**ADDENDUM NO. 1**  
**WILLIAMS STREET SEWER REPAIR (RFP)**  
**CONTRACT NO. W-07-002**  
**CITY OF CHATTANOOGA, TENNESSEE**

**CONTRACT #W-07-002**  
**WILLIAMS STREET SEWER REPAIR**  
**RFP PRE-SUBMITTAL MEETING MINUTES**  
**August 1, 2007**

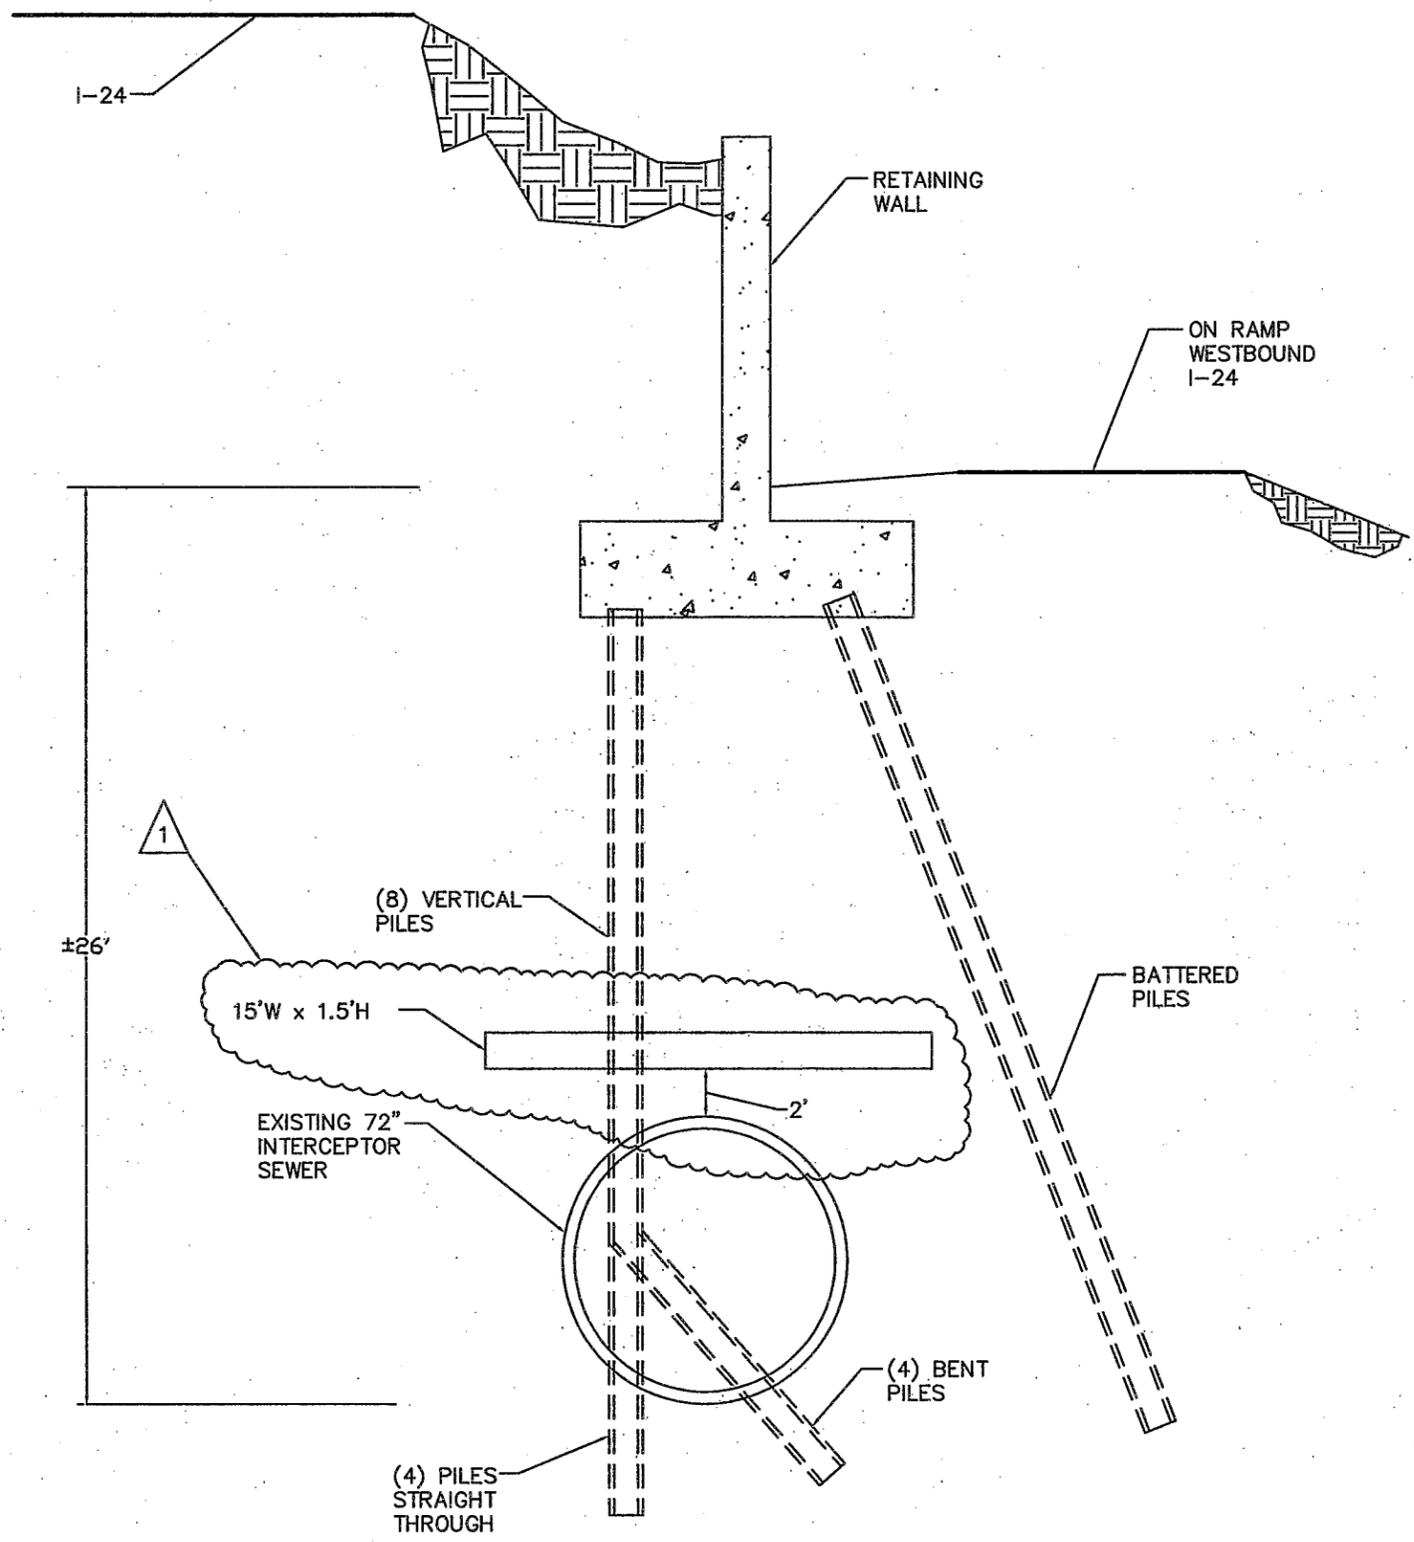
12. On Attachment 'C' drawing, Gordon sketched in the concrete protection slab over the pipe, and distributed to those in attendance. It is 15' W x 18"D, approximately 2 feet above the pipe. Revision 1 to Attachment 'C' is attached.

*A. Remove Attachment 'C' and Replace with Attachment 'C' Rev. 1*

CORRECT \_\_\_\_\_ ENGINEER OF STRUCTURES  
APPROVED \_\_\_\_\_ DIRECTOR OF HIGHWAYS  
M-209-382

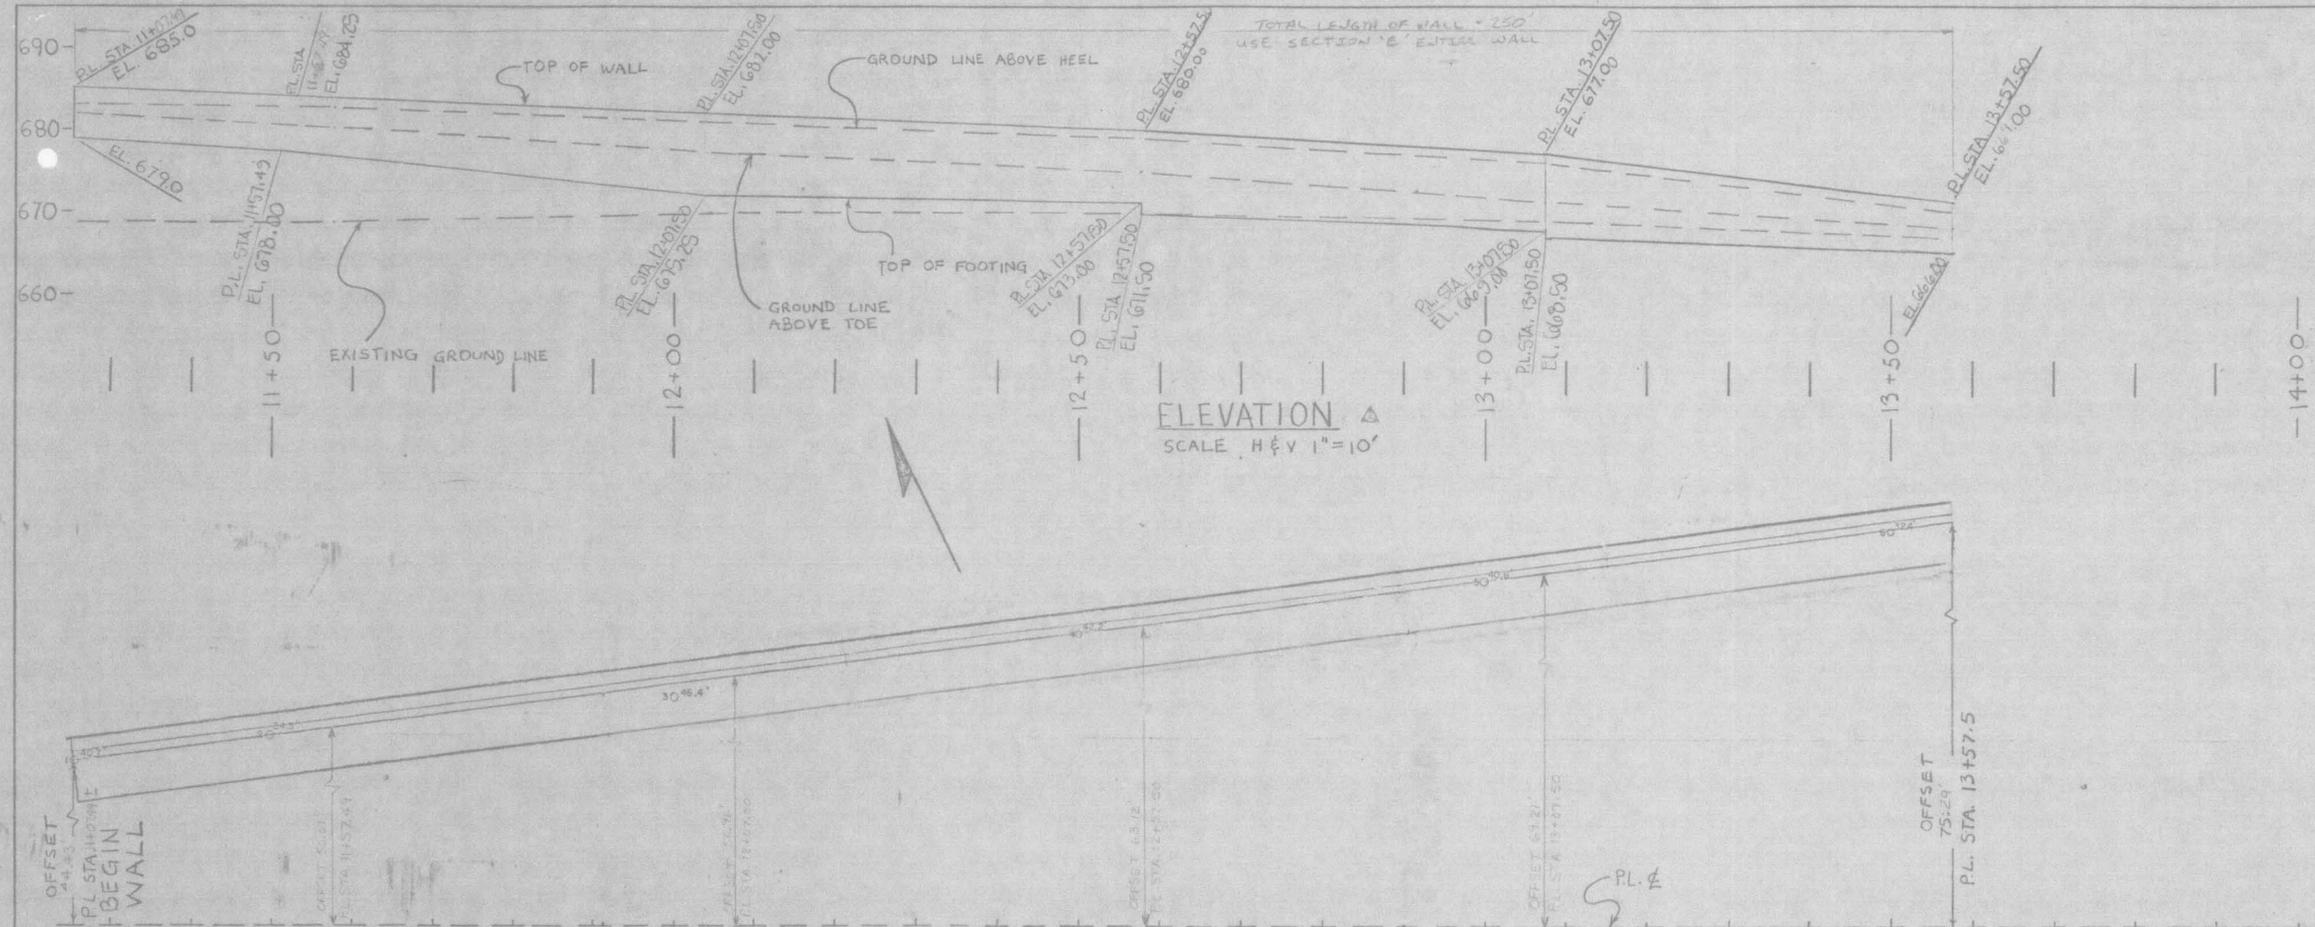
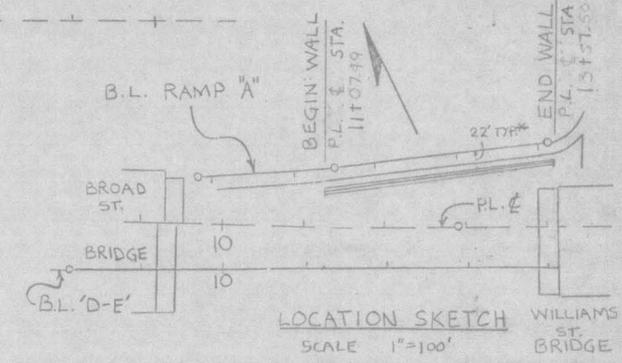
3. *Does the City have a copy of the TDOT drawing?* Yes. Plan View, P&P of Retaining Wall (M-209-382), and Retaining Wall Details (M-209-390) (PDF's Attached). If necessary a full size sheet may be acquired at the TIC of the DRC.

**50715**  
**LINE NO. 1**  
**134-A-4**

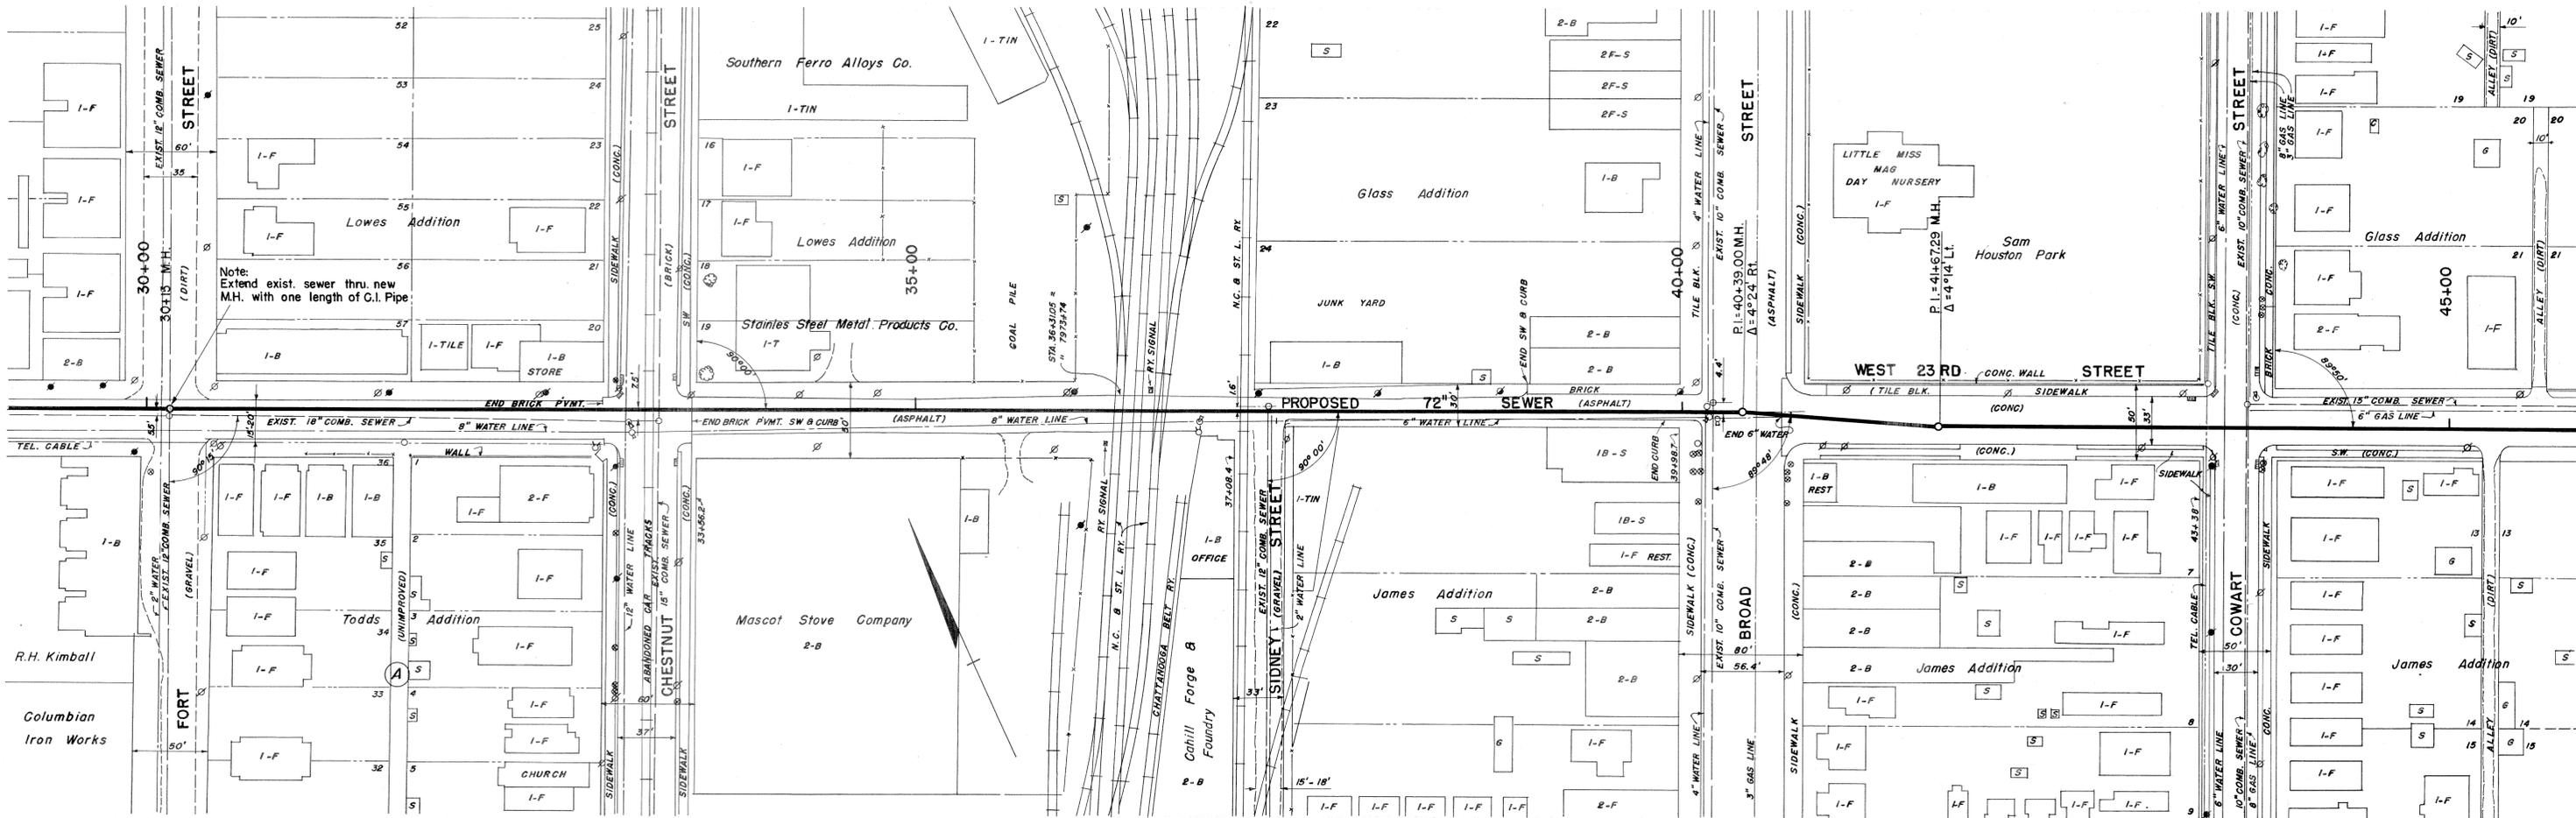
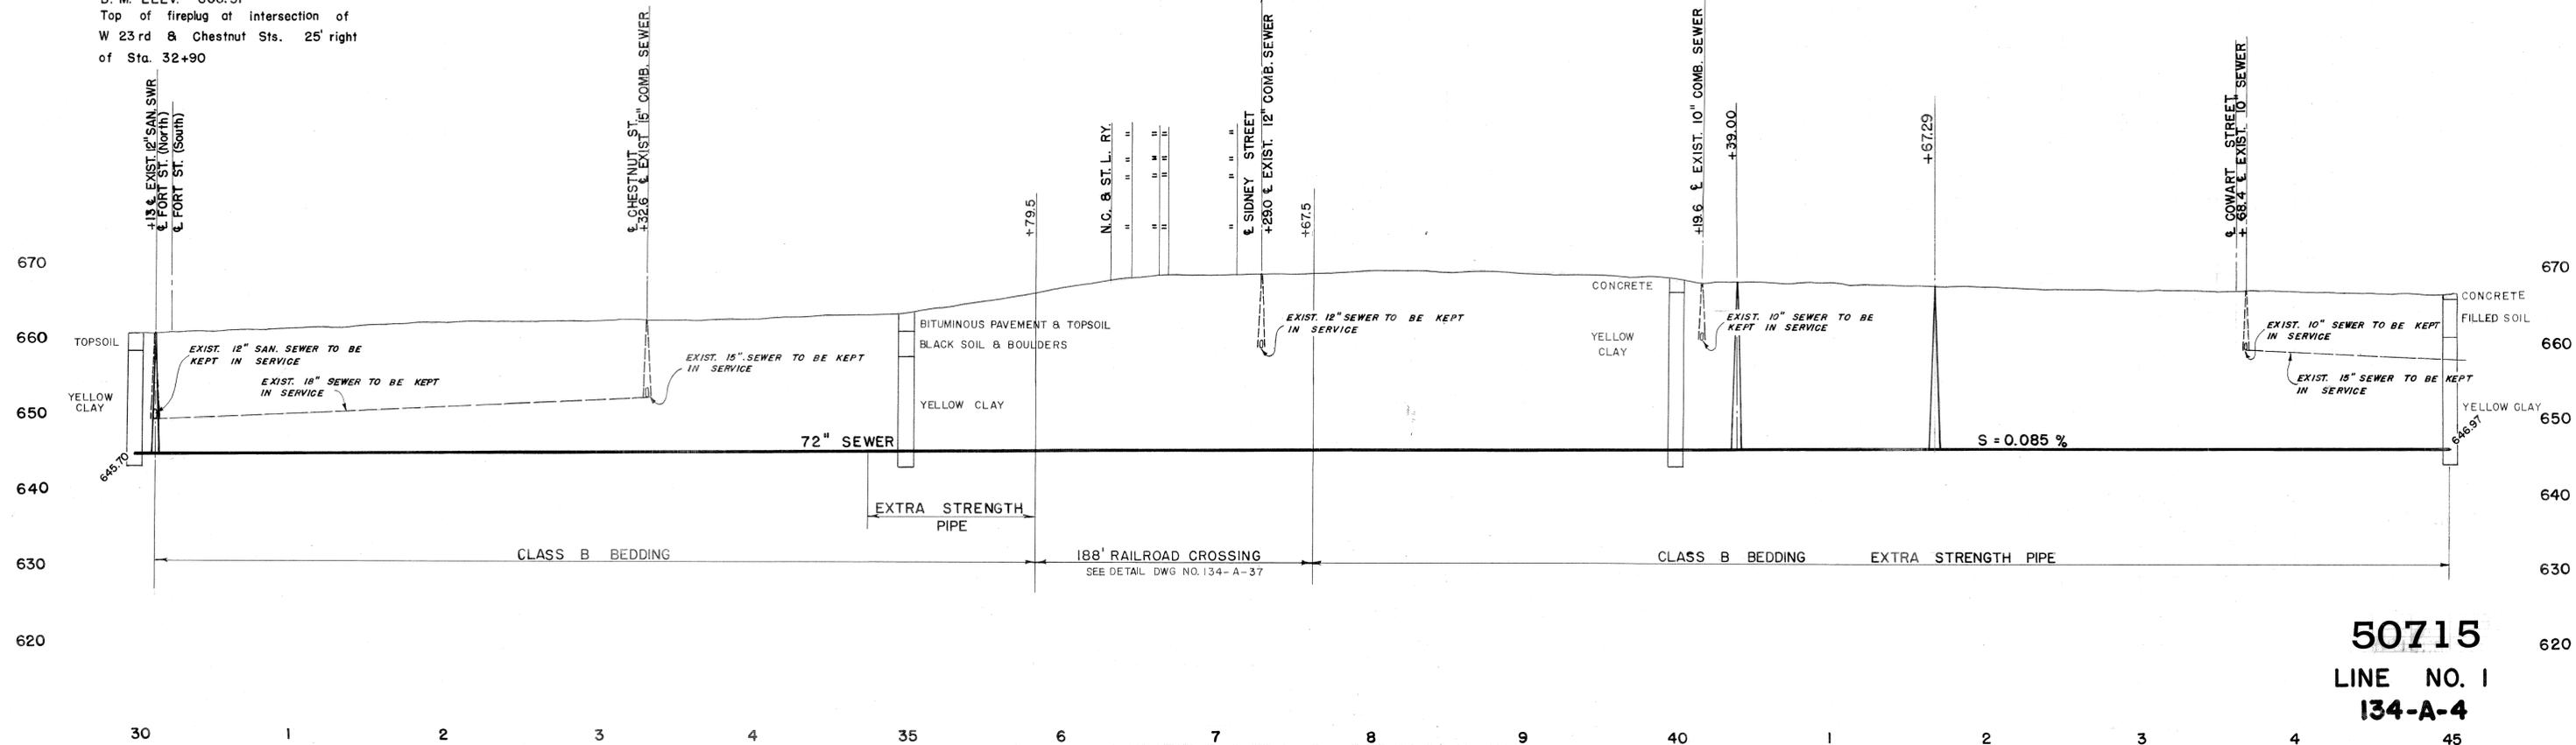
20. *Does the City have As-built information of the sewer line build back in 1955?* Yes. MF#50715 and #50716(PDF's Attached). If necessary a full size sheet may be acquired at the TIC at the DRC.
